The Sizewell C Project

2.8 Ch Two Village Bypass Plans for Approval

July 2021

Two Village Bypass Plans For Approval – Revisions Schedule

DRAWING TITLE:
 TWO VILLAGE BYPASS
 SITE CLEARANCE PLAN
 SHEET 1 OF 2

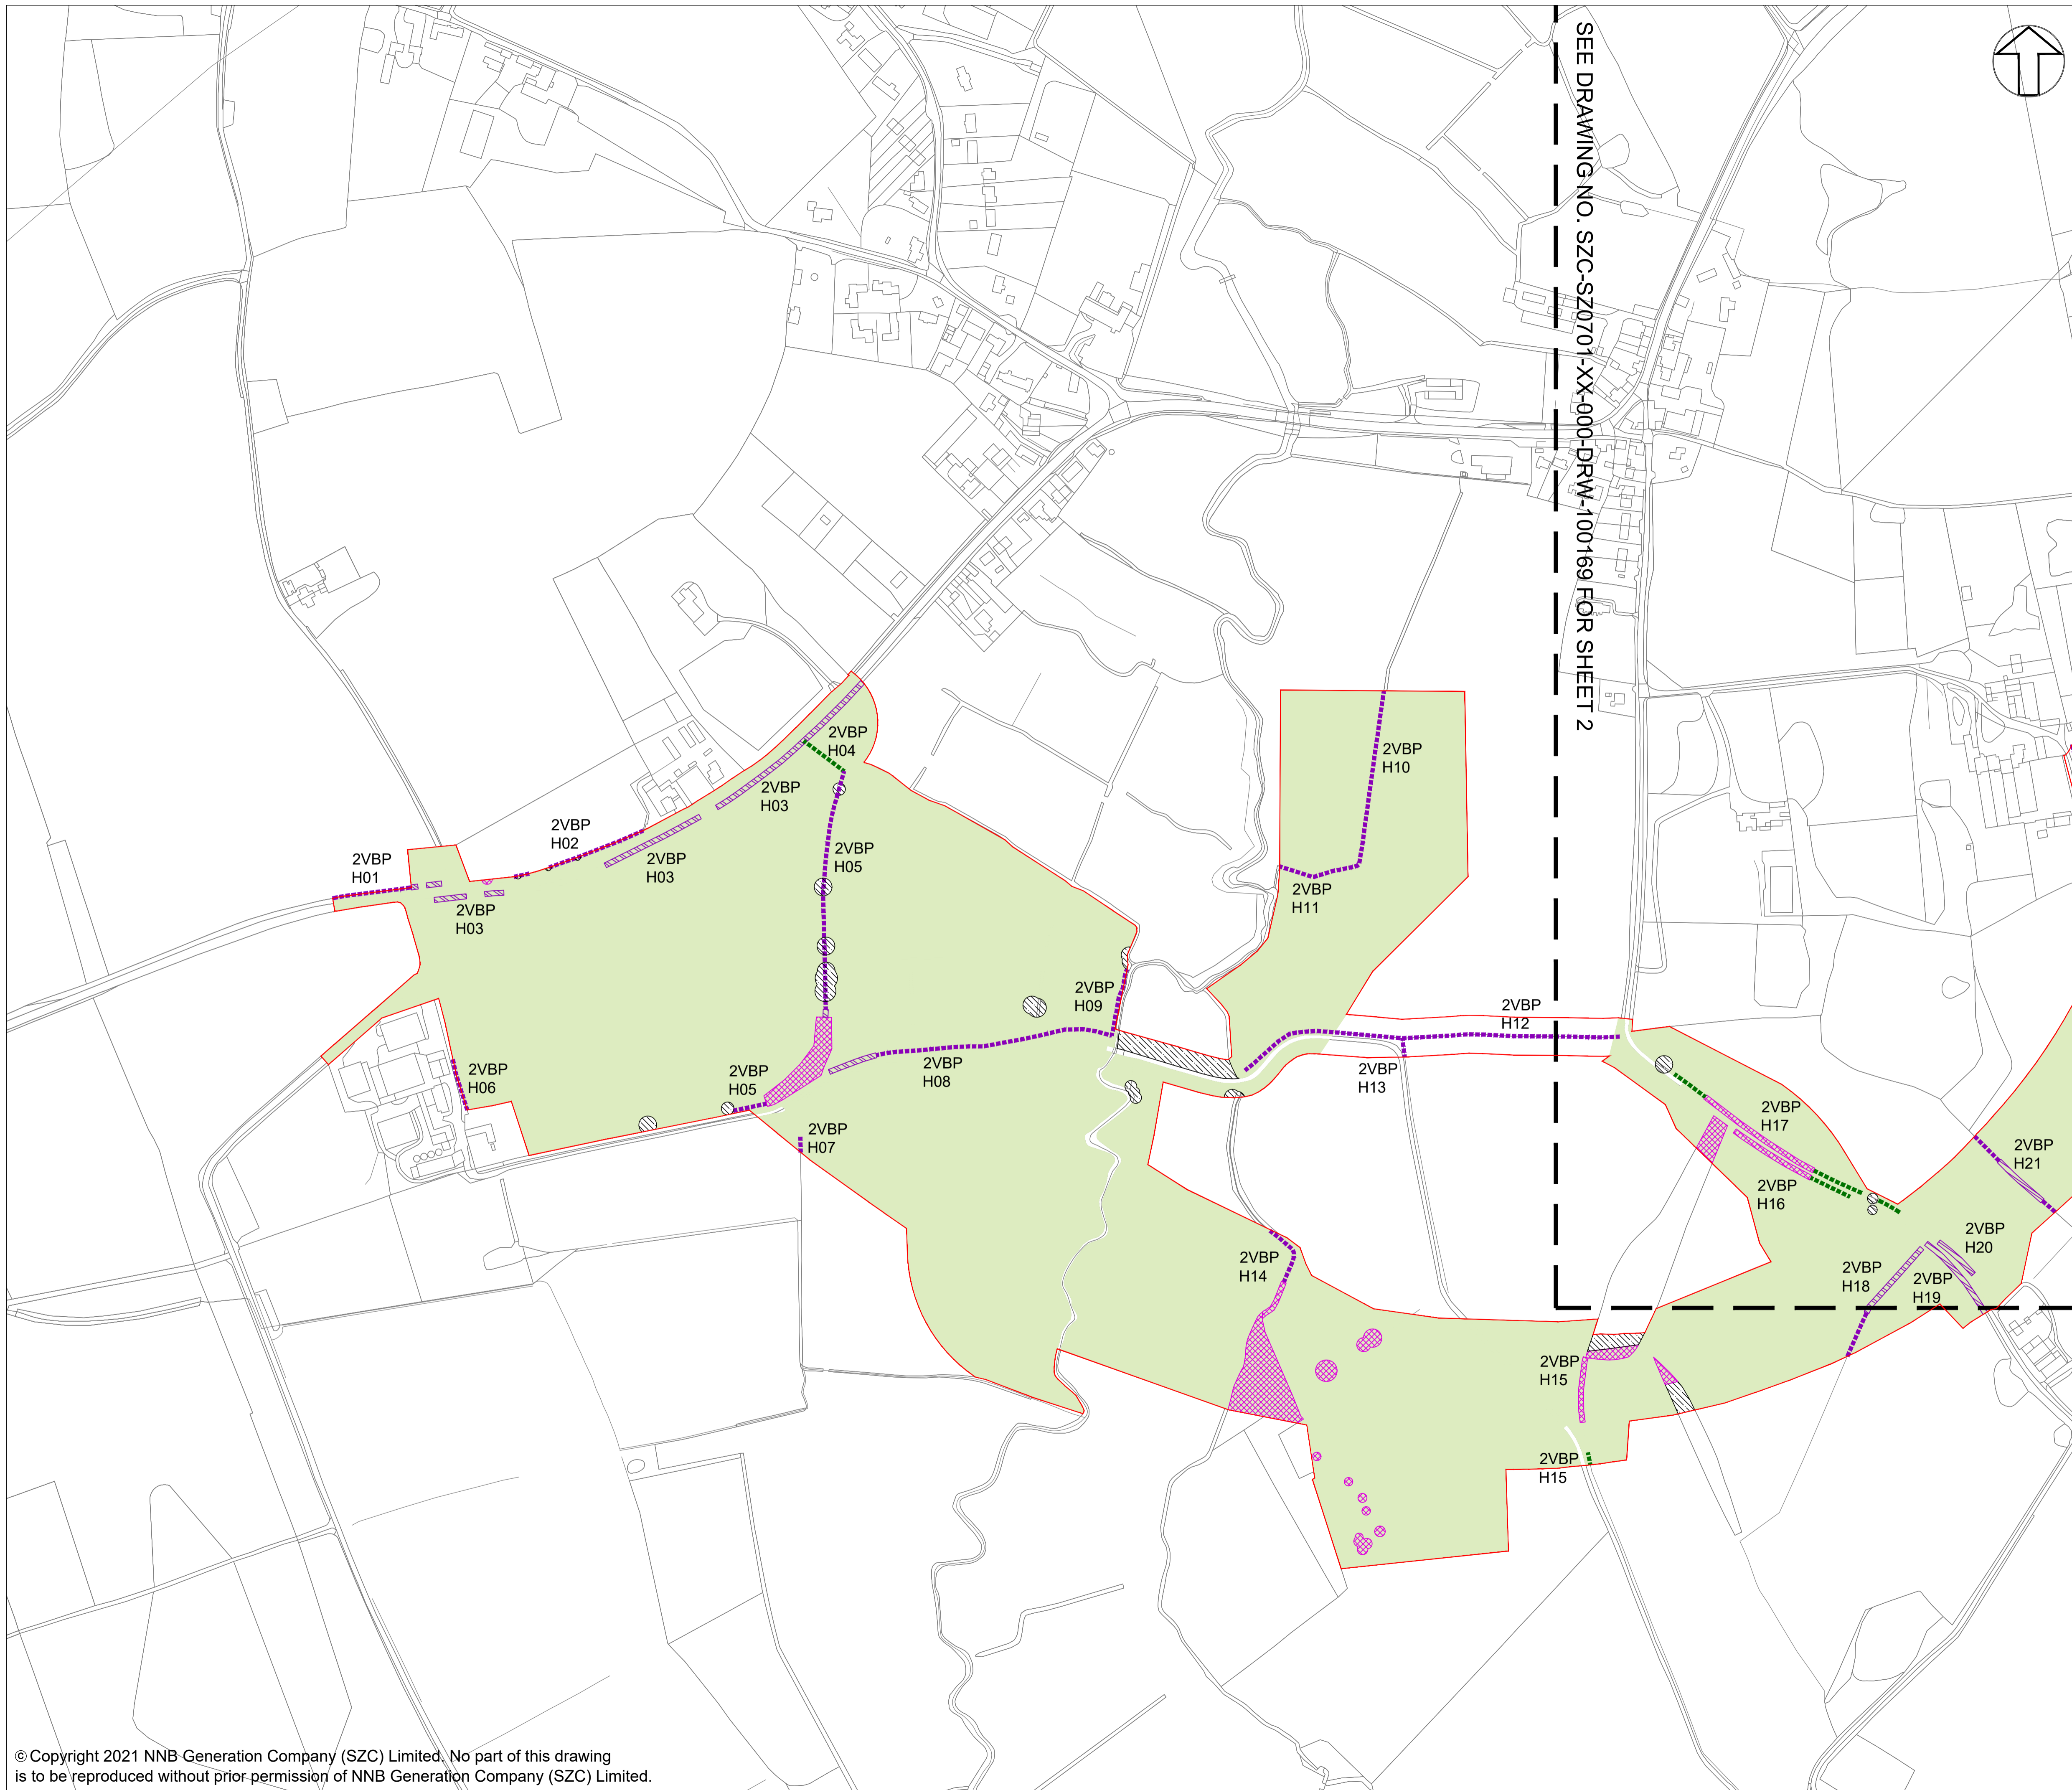
SZC-SZ0701-XX-000-DRW-100168	03	Two Village Bypass Site Clearance Plan - Sheet 1 of 2	Reflect changes to Order Limits.
SZC-SZ0701-XX-000-DRW-100169	04	Two Village Bypass Site Clearance Plan - Sheet 2 of 2	Reflect changes to Order Limits.
